FPL Energy
Seabrook Station

MEASUREMENT UNCERTAINTY RECAPTURE FPLE/CALDON® - NRC MEETING

December 16, 2005

An 8-path chordal LEFM—
the LEFM CheckPlus used for
MUR uprates

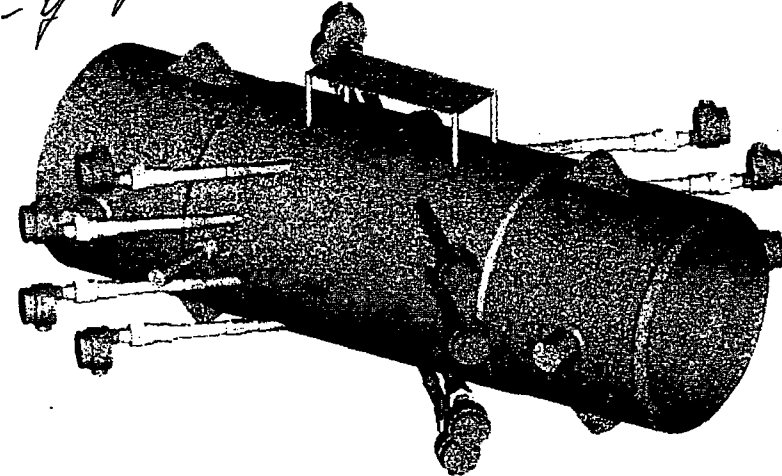
*What about
out-of-plane behavior.*

In the 8 path configuration,
transverse velocity components
exactly cancel ?

Discuss

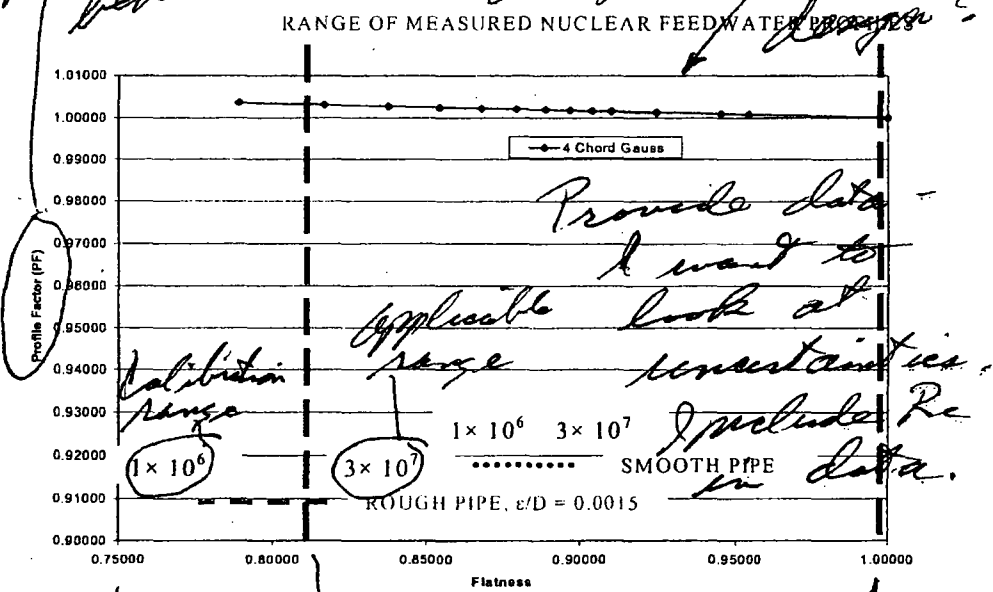
Is this the correction factor for flow rate? Discuss. Indicated vs actual flow rate?

depend on this and discuss behavior. What about long-term change? Which design?

Provide data - I want to applicable look at

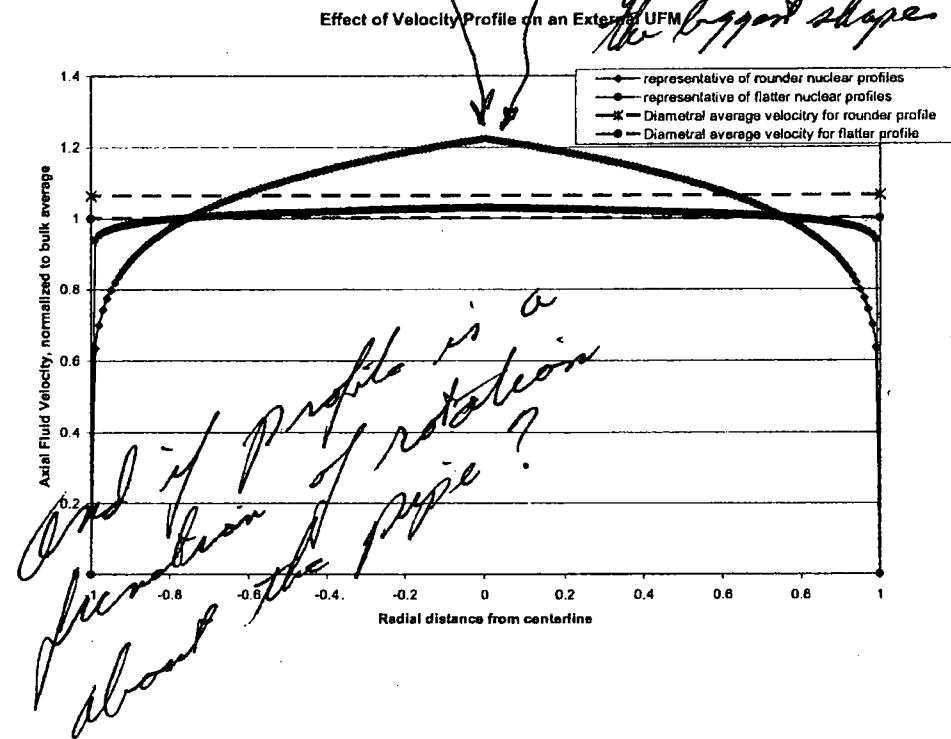
How was this determined? The uncertainty doesn't make sense.

The Alden Research Lab Facility

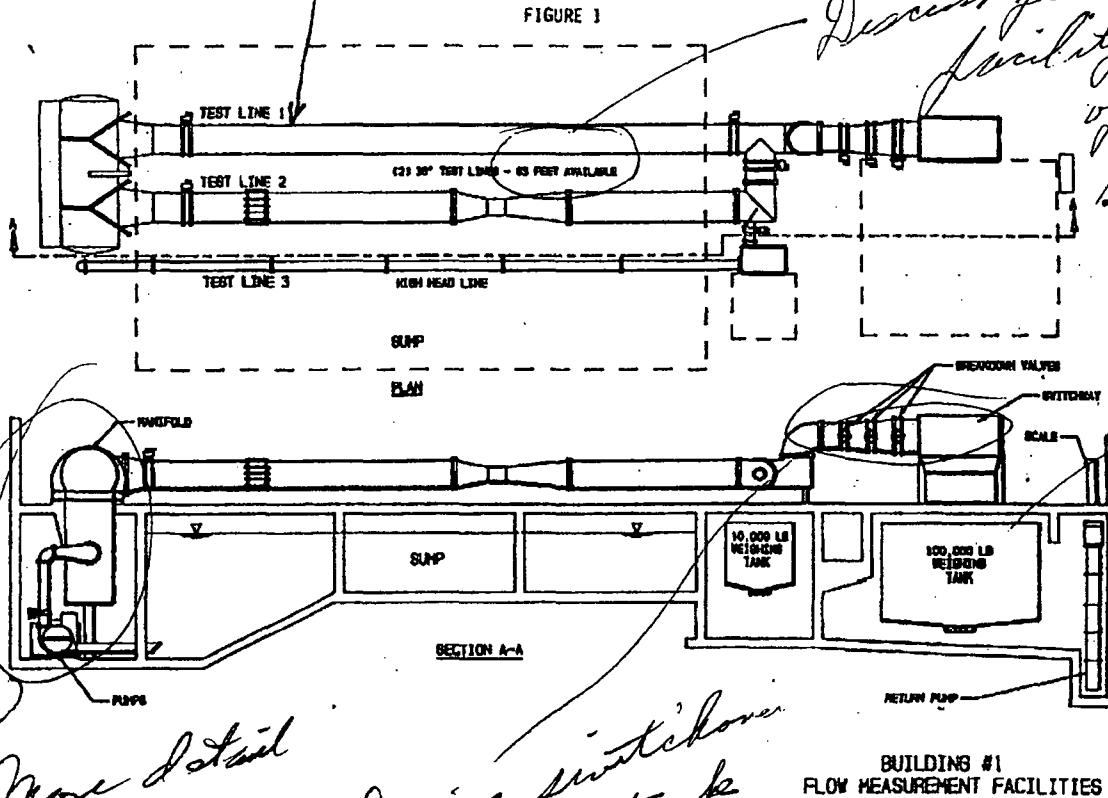
*What are materials?
pipe materials? Effect
of test to plant?*

Discuss flow profile in facility as a function of distance. Include swirl, measurements, calcs (later CFD, more sophisticated if done)

What do data look like as $f(t)$? Provide representative data. Summarize uncertainty.

Provide More detail

Discuss switchover to weigh tanks

Full scale model testing of the
Beaver Valley 2 flow element

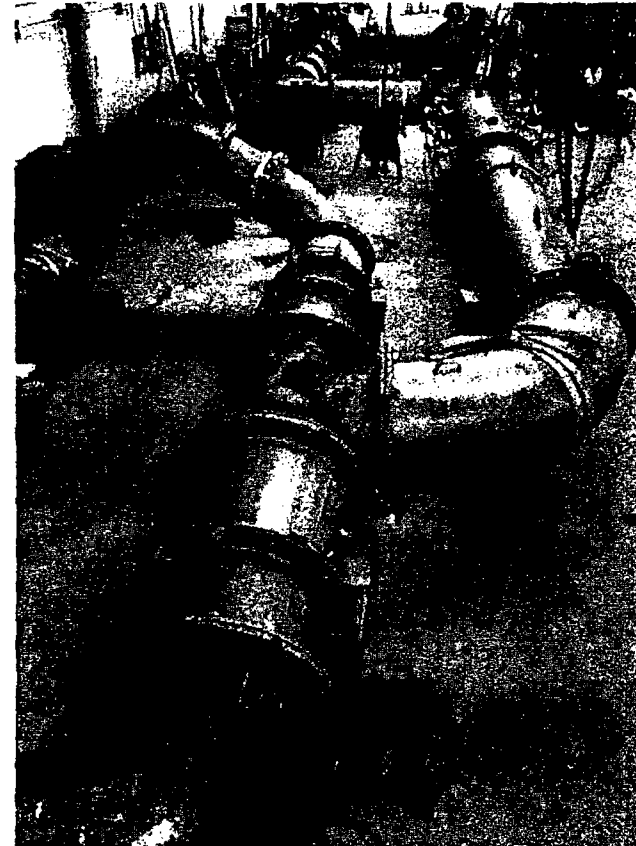
*Discuss effect of
noise, pipe vibration.
Any noise from pumps
at test location?*

Test B-1 Reference configuration

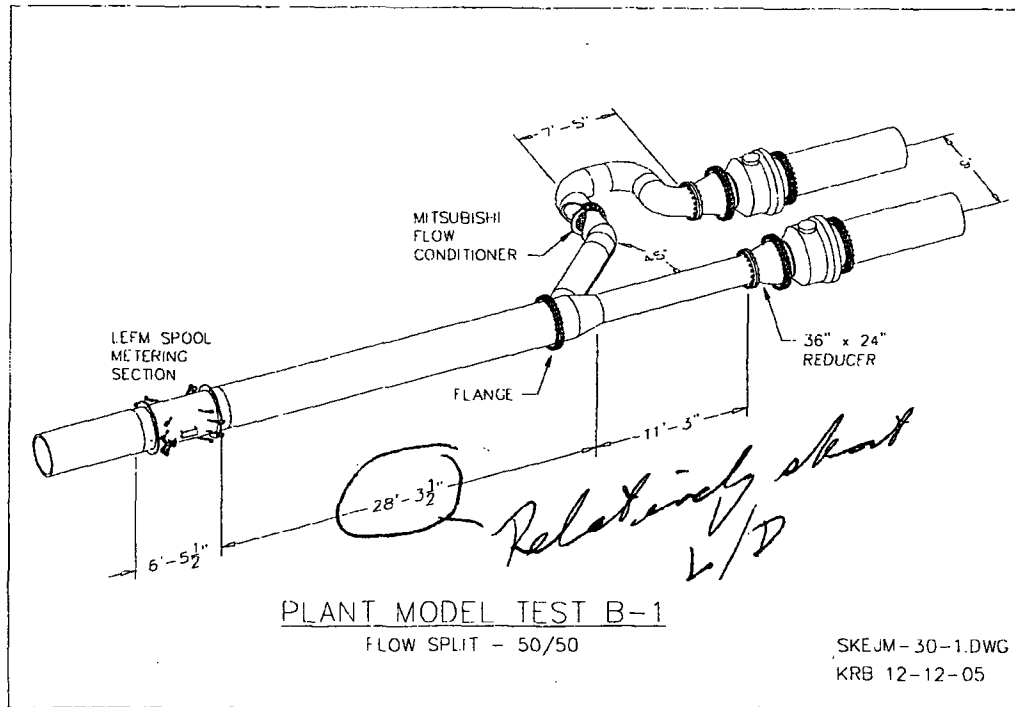
Look at plant config

A sample of the data in ER-486: D.C. Cook Unit 2

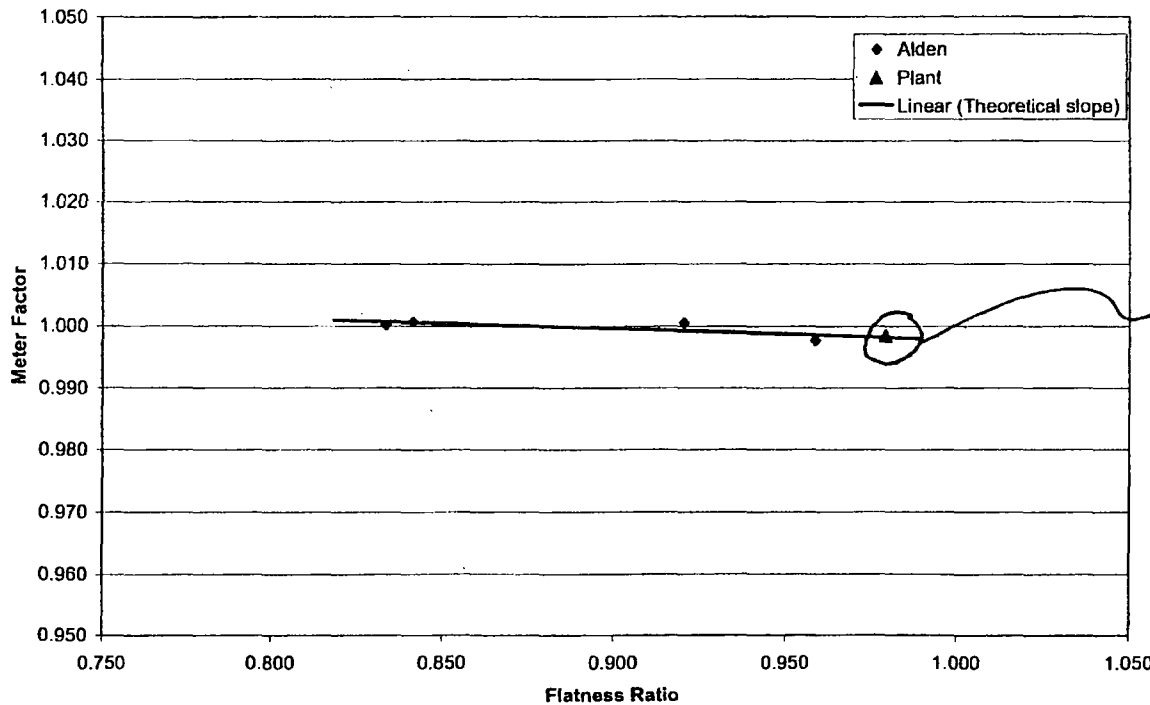
Again - I want the data.

*How was this point determined?
Set by meter factor that was in the meter.*

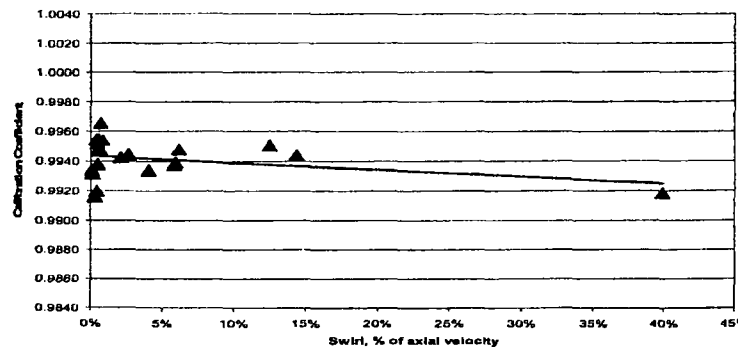
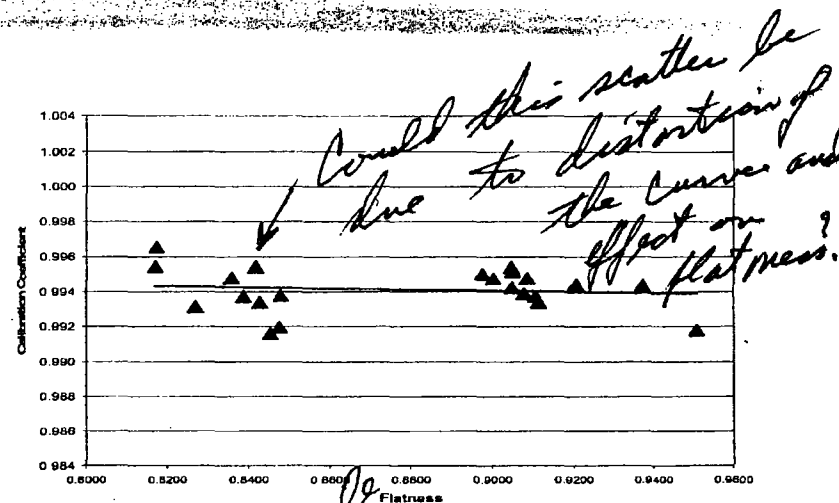
Discuss Sputnik. What's it look like? What do the profiles look like and how does CheckPlus respond?

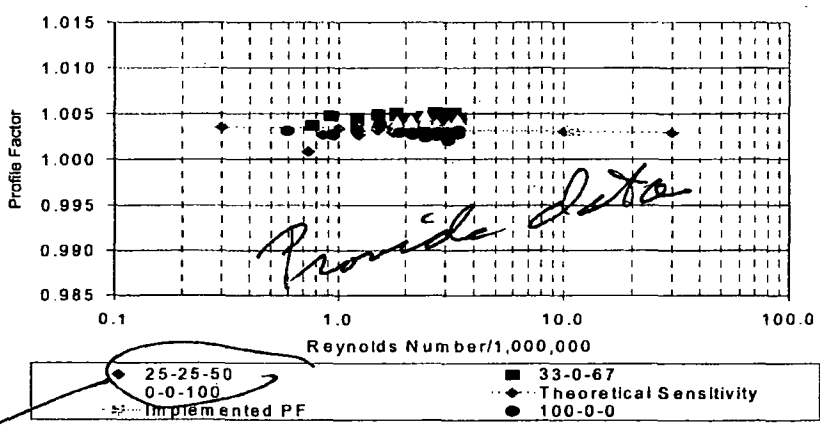
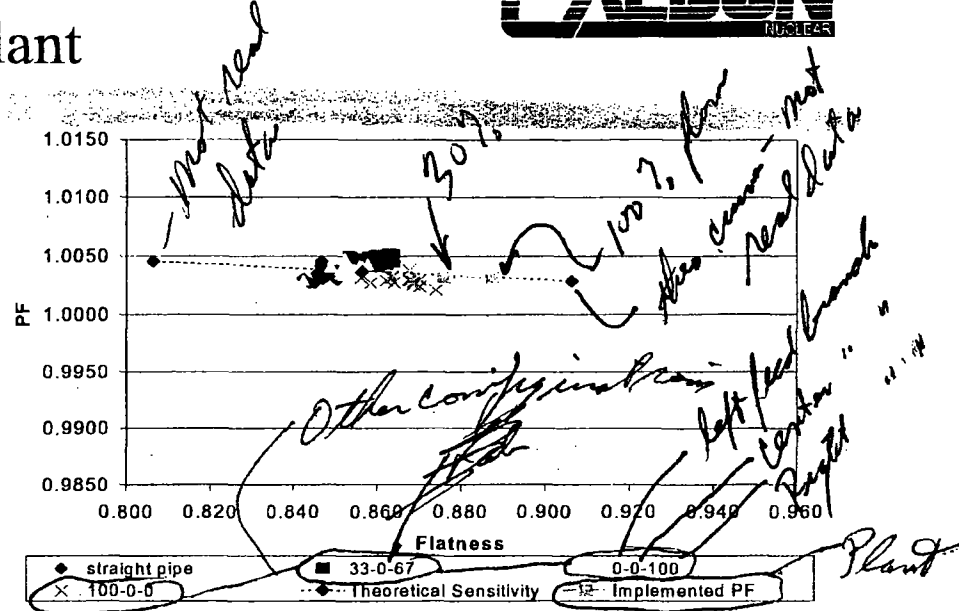
Explain meaning of values
